Chapter 2. The USACE Coastal Spine – A Weakened Ike Dike

Comparison of the Ike Dike Concept and the USACE Plan

Figure 2-2. Schematic of the footprint for the USACE Plan

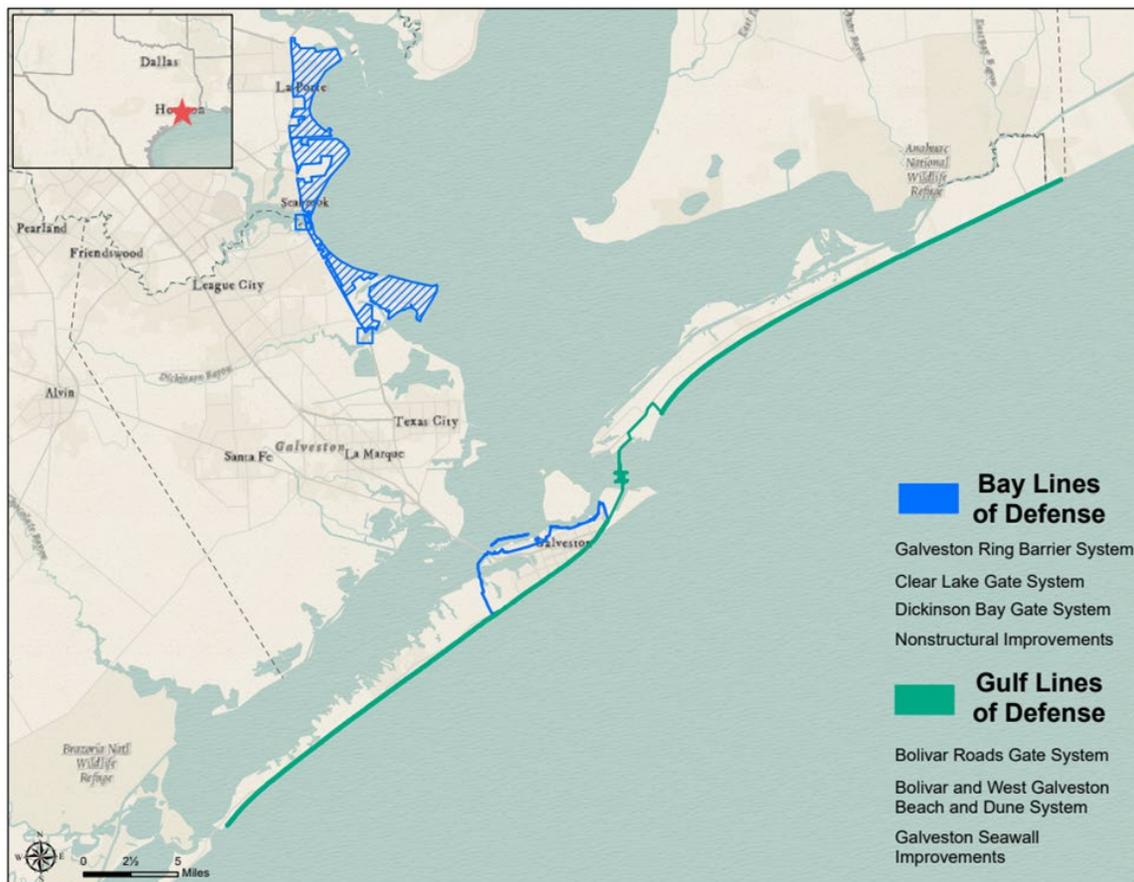
USACE has picked up the Ike Dike concept but made it much weaker, to the point that the land barrier in the USACE Plan provides minimal benefit in reducing damage and flood risk. The Ike Dike concept is intended to shorten and strengthen the coastal surge defenses (like the Dutch approach); and keep water out of the bays to limit internal surges. The USACE Plan severely compromises both core objectives; and it does so in two ways: 1) by adopting a low easily erodible sand dune system for the land barrier on Galveston Island and Bolivar Peninsula, and 2) by omitting the western section of the coastal spine, including the San Luis Pass gate system, which the Ike Dike concept includes. Even with the USACE Plan considerable residual damage and risk remains throughout the region that lies behind the coastal spine. In contrast, a robust Ike Dike, with a strong land barrier and a western section having a gate system at San Luis Pass, substantially reduces residual damage and risk throughout the entire region, compared to the USACE Plan.

Both the beach/dune erosion modeling described in USACE (2020) and the modeling and analyses presented in the next chapter, Chapter 3, show that the low dual dune system in the USACE Plan performs poorly for hurricanes, even weak hurricanes. For example, USACE beach/dune erosion modeling showed that the proposed dual dune system is flattened completely in their simulation of Hurricane Ike, which produced a measured peak surge level of 11 ft NAVD88 at the Galveston Pleasure Pier (lower than the heights of the 12- and 14-ft dunes). The stage-frequency curve shown in Figure 2-22 of Appendix D to USACE (2020) shows that a peak surge of 11 ft corresponds to a return period of 30 years.

Unlike the Ike Dike concept, the coastal spine in the USACE Plan notably lacks continuity between the hurricane protection levee system at Freeport and the west end of Galveston Island, leaving open a “back door” that enables surge propagation into both West and Galveston Bays. Omitting the western section of the coastal spine, which includes a gate system at San Luis Pass, allows the hurricane surge forerunner to propagate through San Luis Pass, into West Bay, and then into Galveston Bay, albeit with a reduced amplitude. Omission also enables the main surge to flank the western end of the USACE coastal spine, first through San Luis Pass and then over an inundated Follets Island, enter West Bay, and then to a lesser degree from West Bay into Galveston Bay. Every contribution to water in the Bays increases flood risk and damage. The critical role of the western section, and the consequences of omitting it, are explained further and discussed in more detail in Chapter 4. Several examples of increased inundation and damage arising from omission of the western section, in both Bays, are presented graphically in Chapter 4. We recommend a thorough, quantitative examination of the cost and benefits of providing a continuous first line of defense in this region, including cost avoidance/savings for the Galveston Ring Barrier and all other in-bay measures.

Figure 2-3. Inundation associated with the USACE Plan for 50-yr and 100-yr events, and for the intermediate sea level rise scenario (images extracted from the Storm Surge Modeling StoryMap. Coastal Texas Study web page)

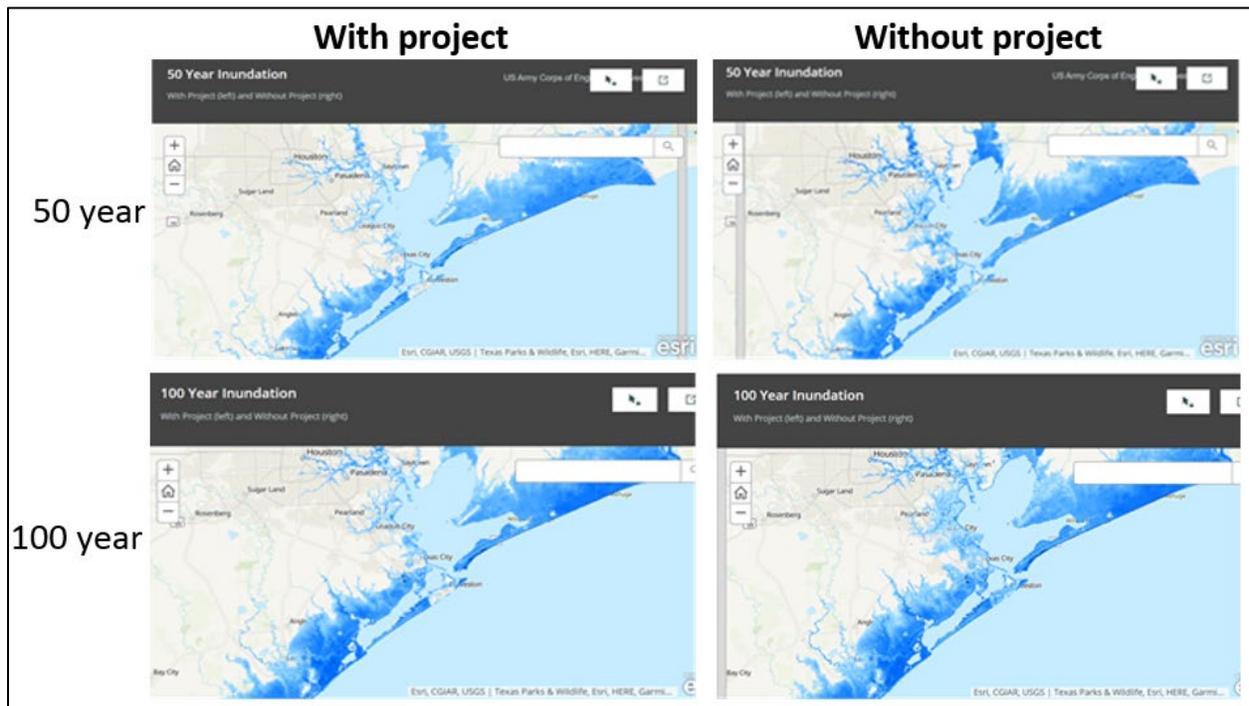
The USACE coastal spine provides limited protection for the region (less than 50 years). The stage frequency curve in Figure 2-22 of Appendix D to the USACE (2020) report shows that 50-yr and 100-yr water levels just offshore of Galveston are 13 and 16.5 ft, respectively, for present sea level (compared to dune elevations of 12 and 14 ft for the USACE land barrier). As illustrated below in Figure 2-3, which shows inundation maps without and with the USACE Plan, the proposed weak land barrier will breach and overflow at 50- and 100-year conditions, resulting in significant inundation, damage and risk. Both Galveston Island (the portion that lies outside the Ring Barrier) and Bolivar Peninsula are completely inundated, as is the entire West Bay north shore and multiple areas of the Galveston Bay periphery.

Poor performance of the low dual dune land barriers in the USACE coastal spine, and omission of the western section, leads to poor performance in reducing damage and flood risk. Despite an expenditure of \$26.17B, the USACE Plan decreases average annual damages by only 60% for the intermediate sea level rise scenario. Even with the USACE Plan in place, residual average annual damage is predicted to be very high, \$1.15B (split this way: 55% in West Bay and 45% in Galveston Bay).

Figure 2-5. Maximum water surface elevation field (in feet, NAVD88) for the future sea level scenario (SLR1, +3.31 ft NAVD88). 17-ft Ike Dike concept for Storm 033 (100-yr proxy)

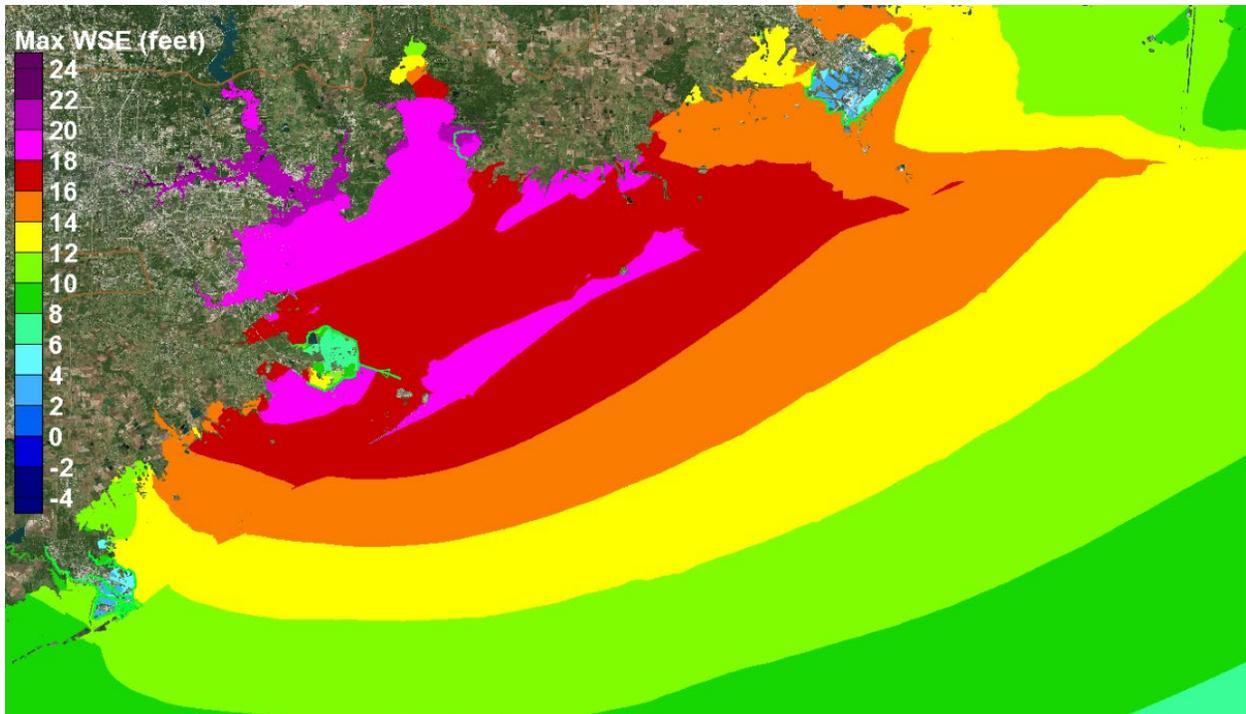
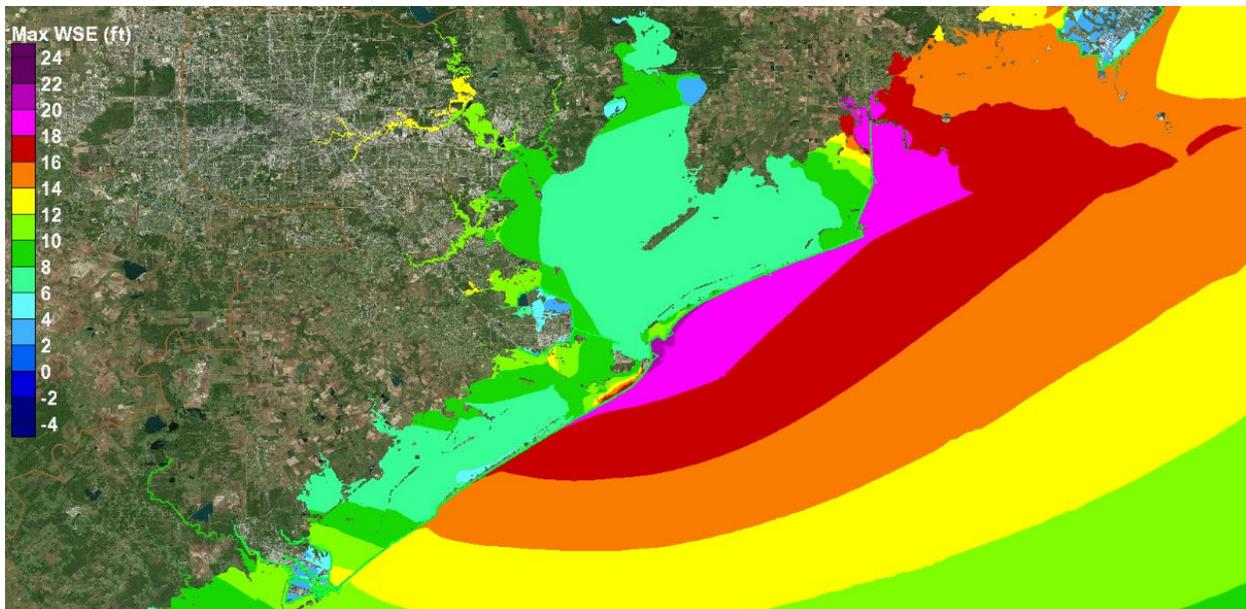
The substantial reduction in peak storm surge achieved with the 17-ft Ike Dike is seen by comparing the peak surge maps in Figures 2-4 and 2-5. The 17-ft Ike Dike reduces peak surge levels by 8 to 10 ft all along the western side of Galveston Bay and into the upper Houston Ship Channel. Reductions in West Bay range from 6 to 8 ft throughout most of the Bay.

As seen in Figure 2-5, peak surge on the Gulf side of the Galveston Seawall ranges from 18 to 20 ft. Evidence that this magnitude of peak surge exceeds the 17-ft elevation of the Seawall, and the resulting steady overflow that occurs, is evidenced in Figure 2-5 by the high peak surge values immediately behind the Seawall in the City of Galveston. With improvements proposed by the USACE, the Seawall will be raised to an elevation of 21 ft. If the Ike Dike simulation for Storm 033 had included a 21-ft high Seawall, overflow of the Seawall into the City of Galveston would have been eliminated. Had a 21-ft Seawall been included in the simulation, we expect that results would show a peak surge of 8 to 9 on the bay side of the City of Galveston, a reduction of 9 to 10 ft.

The peak surge for the 100-yr proxy storm on the Gulf side of Galveston, and future sea level, 18 to 20 ft, is nearly the same as the future 100-yr water level at the same location for the USACE Plan, 18.6 ft (estimated from information provided in the USACE Feasibility Report). In light of the similarities in future sea level and open cost 100-yr peak surge values, comparisons can be made between the 100-yr proxy storm results for the 17-ft Ike Dike and 100-yr design water levels for the USACE Plan provided in USACE (2020). For the USACE Plan, future with-project 100-yr water levels on the bay side of the City of Galveston range from approximately 10.3 to 12.3 for present sea level and 12.4 to 14.4 ft for future sea level. As discussed above, we expect values for the 17-ft Ike Dike to be 8 to 9 ft, which is 3 to 4 feet lower than the 100-yr values for the USACE Plan. For the USACE Plan, future with-project 100-yr water levels at the entrances to Dickinson and Clear Lake are 12.8 and 13.5 ft, respectively. Based on results shown in Figure 2-5, we expect values for the 17-ft Ike Dike to be approximately 10 ft, roughly 3 ft lower than the USACE 100-yr water levels.

JSU research indicates that a 17-ft Ike Dike will reduce 100-yr surge levels by 3 to 4 feet in Galveston Bay, and by 3 to 6 ft in West Bay, compared to the USACE Plan. It is important to note that once the flaw in the USACE storm surge modeling is corrected, The USACE design water levels inside the bay will increase, and the improvement offered by the Ike Dike concept will increase as well. The 17-ft Ike Dike is far superior to the USACE Plan in reducing flood risk for the entire region. It will significantly reduce residual damages throughout the region, along the peripheries of both bays. It will reduce the extent of, and the required height and strength and cost of, all in-bay measures, eliminate the need for many of them, reduce the required elevation and cost of the Galveston Ring Barrier (discussed in Chapter 5) and the wall/gate systems at Clear Lake and Dickinson. We expect that a 17-ft Ike Dike will enable compliance with the 100-yr design standard (and for future sea level) for a Galveston Ring Barrier having an elevation of 13-14 ft. The 17-ft Ike Dike will not meet the 100-yr design standard for the land barrier (an elevation approaching 24 or 25 ft would be required to do so for the future intermediate sea level rise scenario), but it represents a compromise to address preferences for a lower barrier. With a foot or two of sand cover over a 17-ft solid core, the crest elevation is roughly equal to the current base flood elevation (18-19 ft) for FEMA VE Zones located adjacent to the shorelines of Galveston Island and Bolivar Peninsula. It is much more consistent in elevation and protection level with the 21-ft Seawall than the 12 and 14-ft dunes in the USACE Plan.

We recommend lowering the height of the Bolivar Roads Storm Surge Barrier to 19 or 20 ft, something a little less than the height of the Seawall. In terms of flood risk reduction for the region, there is little value in setting the height of the 2-mile long Bolivar Roads Barrier to be higher than the 43-mile-long land barrier. However, by setting the height at 19 or 20 ft, it would avoid having to raise the Bolivar Roads Barrier if a decision was made in the future to raise the height of the land barrier to accommodate a higher rate of sea level rise. The 19 or 20 ft Barrier likely meets the 100-yr design
